1CAN020009

Subject: Arkansas Nuclear One - Unit 1
Docket No. 50-313
License No. DPR-51
Modified Approach for Analyzing Repair of ANO-1 Hot Leg
Nozzle RC-1071/1072

**Analysis of ANO-1 Hot Leg Nozzle Weld
Pad Build-up Repair**

Figure 3

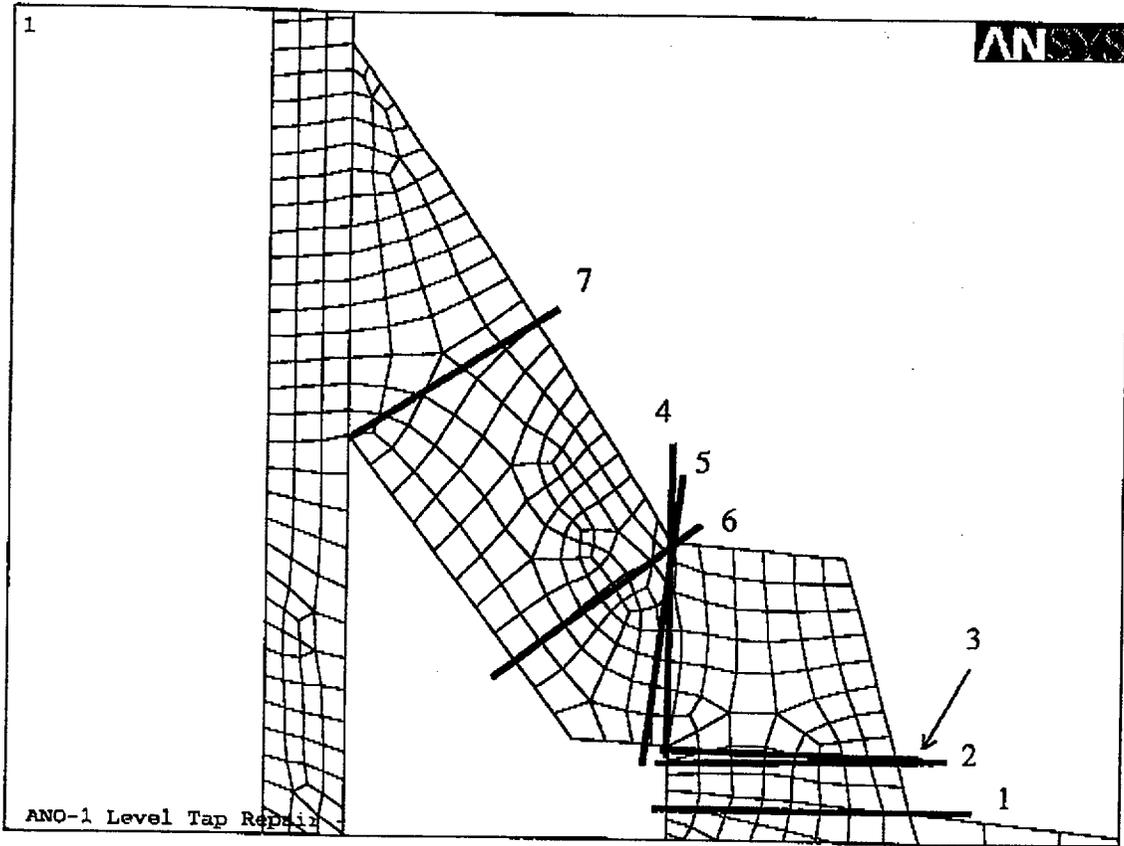
The analysis conducted by FTI reported results for allowable membrane stress at the worst location in the deposited weld material and adjacent piping (see Section 1 in Figure 3 included in the attachment). The FTI calculation used an allowable stress of $S_m = 18.4$ ksi (associated with the adjacent pipe material at Section 1). The allowable stresses for Alloy 690 (SB-166/167/168, UNS N06690) from Code Case N-525 (Approved December 9, 1993) is $S_m = 20.0$ ksi, at all

temperatures up to 800°F. Thus, the flow stress could be taken as 60.0 ksi at all temperatures. Therefore, additional margin exists in the austenitic weld overlay material adjacent to the flaws remaining in the underlying weld material. Code Case N-525 has not received NRC approval, however the allowable stress values are more conservative than those contained in previously approved Code editions for similar UNS N06690 materials.
